**Project: 21-122-100-R****June 6, 2023****Neatt Communities****via email: [Colin.Rauscher@neattcommunities.com](mailto:Colin.Rauscher@neattcommunities.com)****Re: Additional Comments Regarding Impact Slope Stabilization Methodology  
150 Steeles Avenue East, Milton**

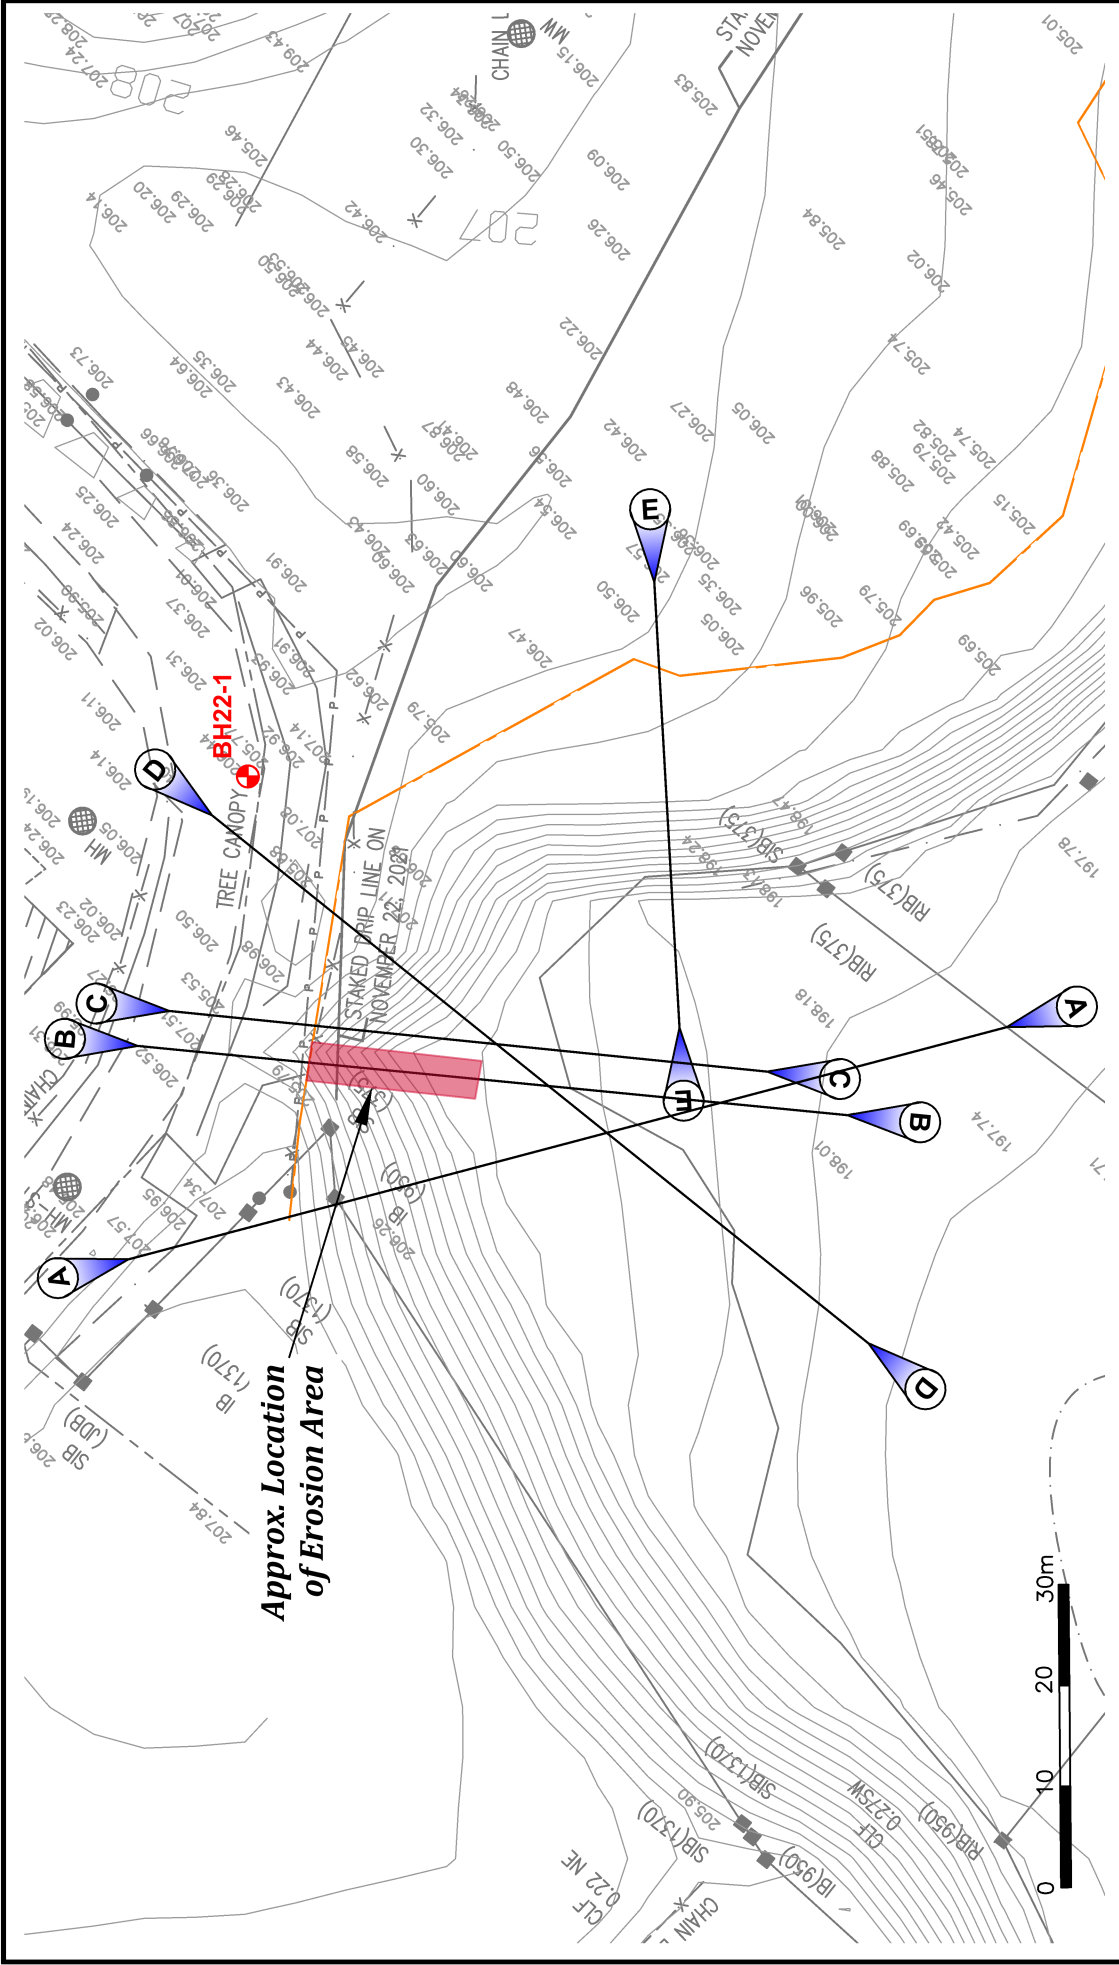
Further to the recent comments from Conservation Halton (CH) and Halton Region (the Region) we extend the following comments in regards to the methodology/approach for stabilization of the eroded slope (Section B-B on attached Drawing 1) at subject site noted above.

Field measurements of the failed (eroded) slope area (must be confirmed by proper survey conducted by a licensed surveyor) were obtained by DS and are presented in plan and profile on attached Drawings 1, 2 and 3. The affected area measures approximately 17 m in length, 7.3 m in width and on a depth of about 5.0 m at its deepest point.

Project: 21-122-103 - **Drawing 6A**  
Slope Profile at **Cross-Section B-B** (See Drawing 1 for Location Plan)

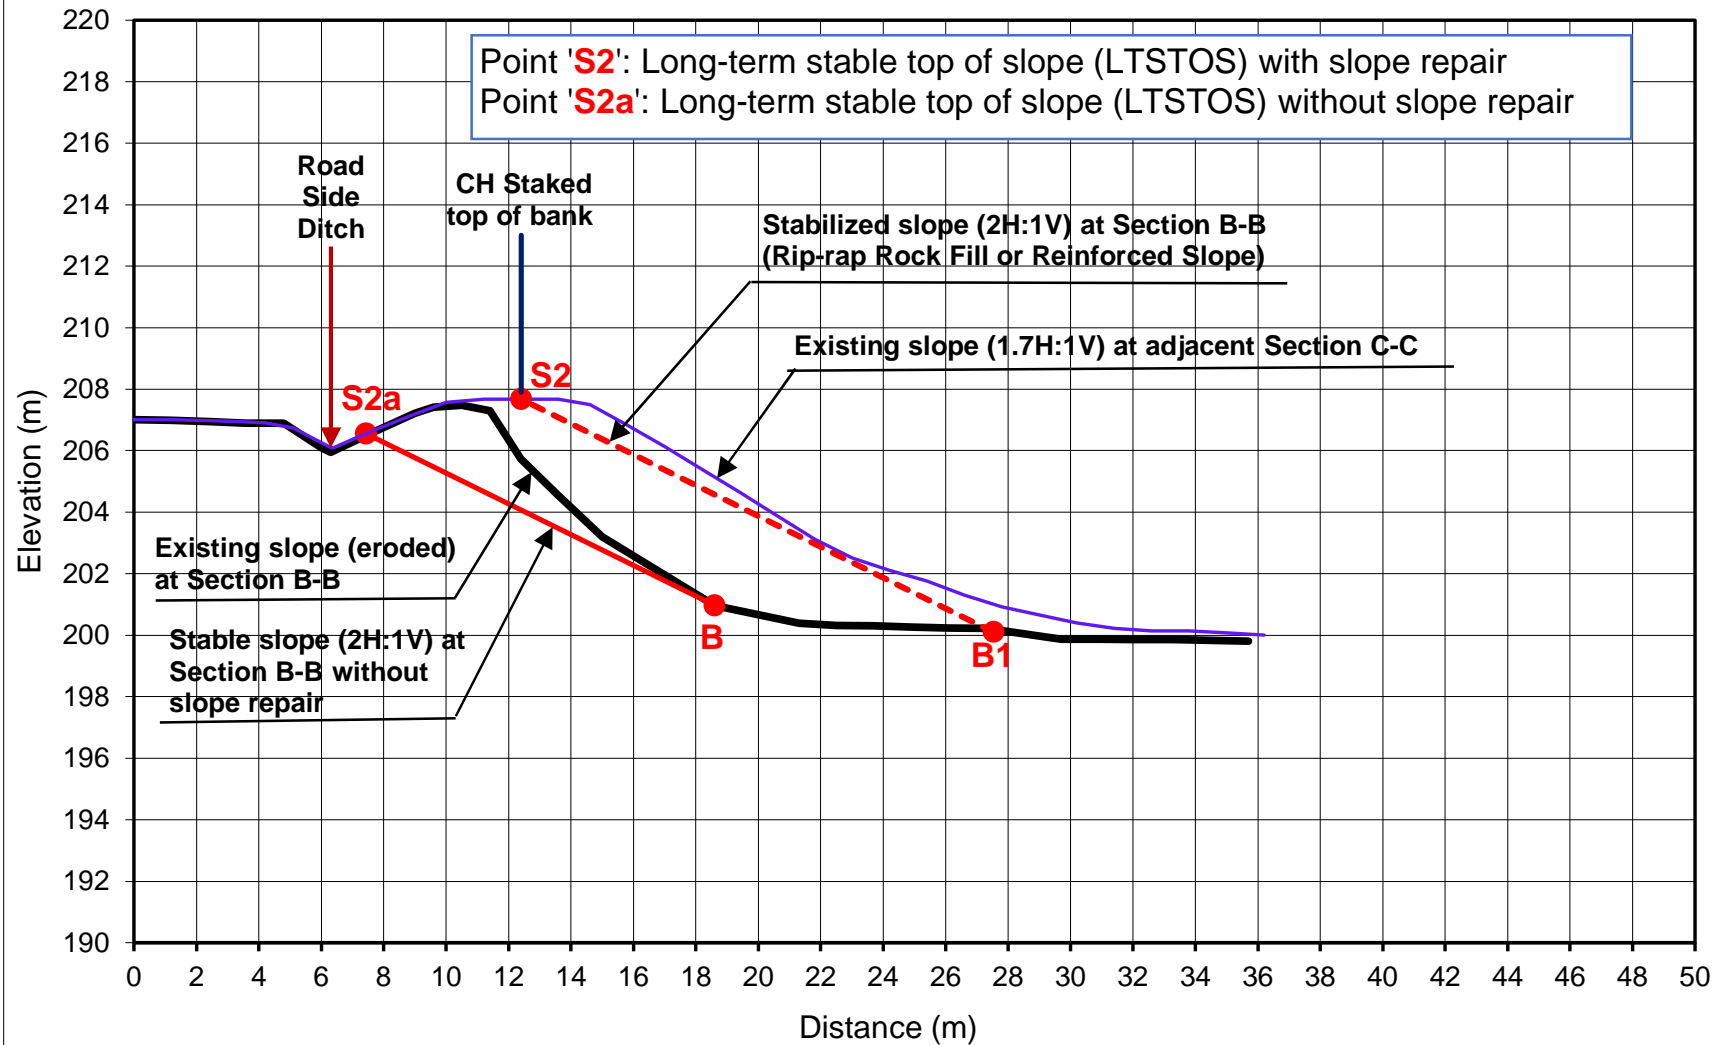
In the Slope Stability Assessment Report by DS (Project No. 21-122-103, January 17, 2023), Drawing 6 presents the proposed slope repair using rip-rap (2H:1V slope). In the attached Drawing 6A, slope repair using soil is shown by Line S2-B2 (2.5H:1V). For soil fill slope, an inclination of 2.5H:1V is required in order to achieve a factor of safety of FS=1.5 required by CH. In Drawing 6A, Point S2 represents the long-term stable top of slope at Section B-B with slope repair using soil. Accordingly, the long-term stable top of slope (LTSTOS) line (S1-S2-S3-S4) in Drawing 1B of the Slope Stability Assessment Report remains the same, regardless of whether rip-rap or soil is used.

The soil used for the slope repair should consist of inorganic soil material compacted to 98% SPMDD (Standard Proctor Maximum Dry Density). The soil type (sandy soil, clayey soil etc.) can be selected by others for vegetation requirements. A 200 to 300 mm thick layer of topsoil can be placed on the top of the repaired slope, if required.

The Study Team considered using soil to repair the slope, as part of the first submission however, deemed it to be more impactful to the environment than using rock (rip rap). Rock stabilization can be completed entirely from the table lands, with no need for large equipment within the valley and little to no disturbance to the adjacent vegetation.
